Village of Lincolnwood Plan Commission

Plan Commission Staff Report

Case # PC-03-24

Subject Property:
6645 & 6657 North Central Park
Avenue

Drawings showing the existing lot lines (left) and proposed lot lines (right)

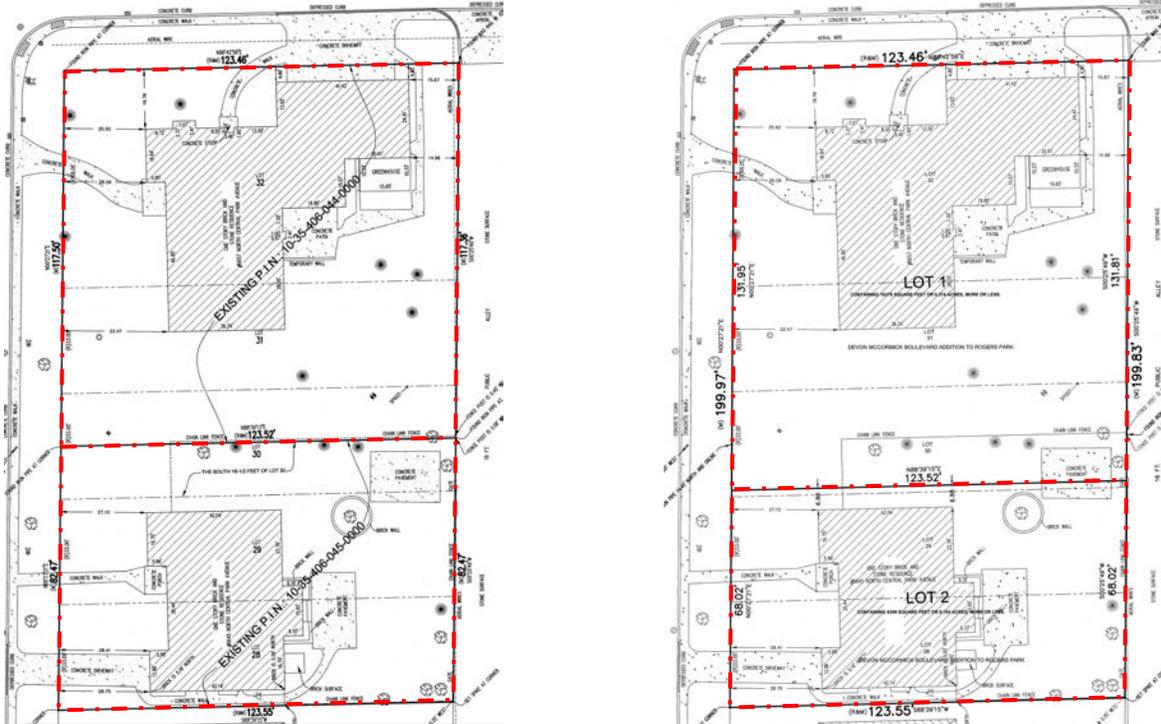
Each of the subject properties currently includes a single-family structure. The Petitioners plan to demolish the home on 6657 North Central Park Avenue in order to develop a new single-family residence. As part of that process, they seek approval of a Plat of Subdivision to relocate the southern lot line of that property south by 14.45 feet.

- The orientation of the yards at 6657 North Central Park, as defined and established by the Zoning Ordinance, will change. On corner lots, the Zoning Ordinance states that the shorter of the lot lines fronting on a public street shall be the front lot line. Currently, that property's front lot line is along North Central Park Avenue. If approved, the proposed Subdivision would result in the new front lot line being along West North Shore Avenue.

- As noted earlier in this section, the required side yard setback at 6645 North Central Park Avenue is 8.2 feet. The proposed Subdivision would result in a reduced interior side yard setback of 6.8 feet. (The applicable setback would only be triggered if the existing structure were to be removed, modified, or added to.) That reduced setback is most relevant to the property to the south (6635 North Central Park Avenue). The structure on that property is currently set back five feet from the lot line it shares with 6645 North Central Park Avenue.

Central Park Subdivision

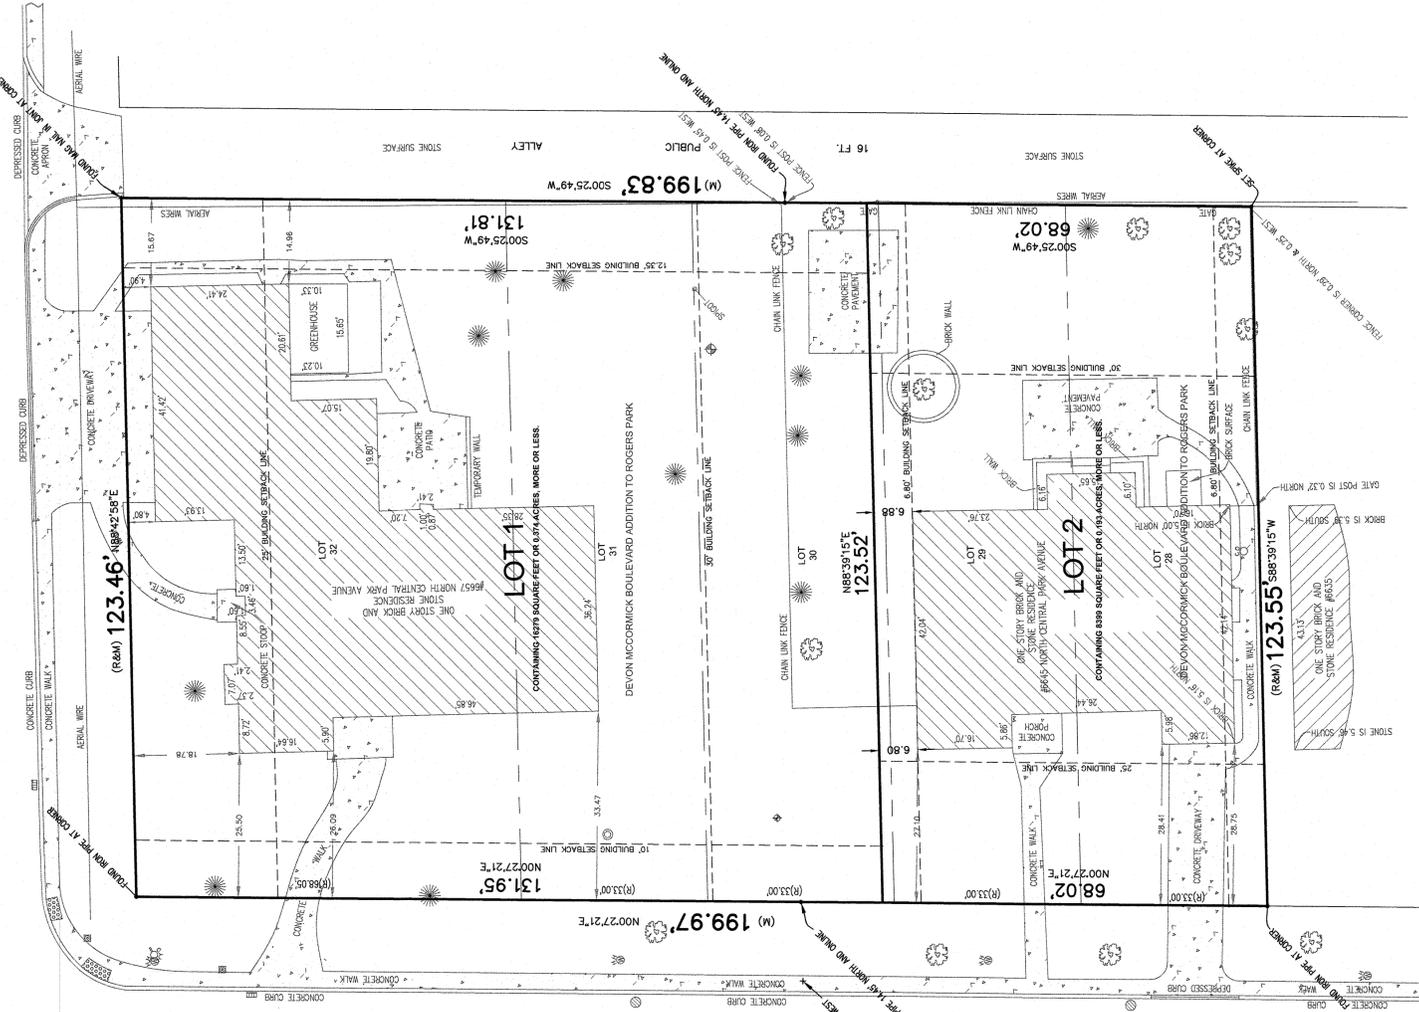
As noted above, approval of the proposed Plat of Subdivision would result in a new front yard setback at 6657 North Central Park Avenue. That setback would be 25’ and would be measured from the West North Shore Avenue lot line. The existing structure on that property would encroach into the new front yard setback. Staff recommends that, as an condition of the approval of the proposed Plat, the structure currently on 6657 North Central Avenue must be demolished prior to the recordation of the Plat.

During review of the proposed Plat of Subdivision, the Village Engineer noted a concrete slab and fence that are currently on the property at 6645 North Central Park Avenue. The relocated lot line between the subject properties would overlap these elements, making them non-conforming. Staff recommends that, as a condition of approval of the proposed Plat of Subdivision, the Petitioner be required to remove that concrete slab and fence and restore the area to flat grade prior to the recording of the Plat.

- That the structure currently on 6657 North Central Avenue be demolished; and
- That the existing concrete slab and fence on 6645 North Central Park Avenue be removed and that its area be restored to flat grade.
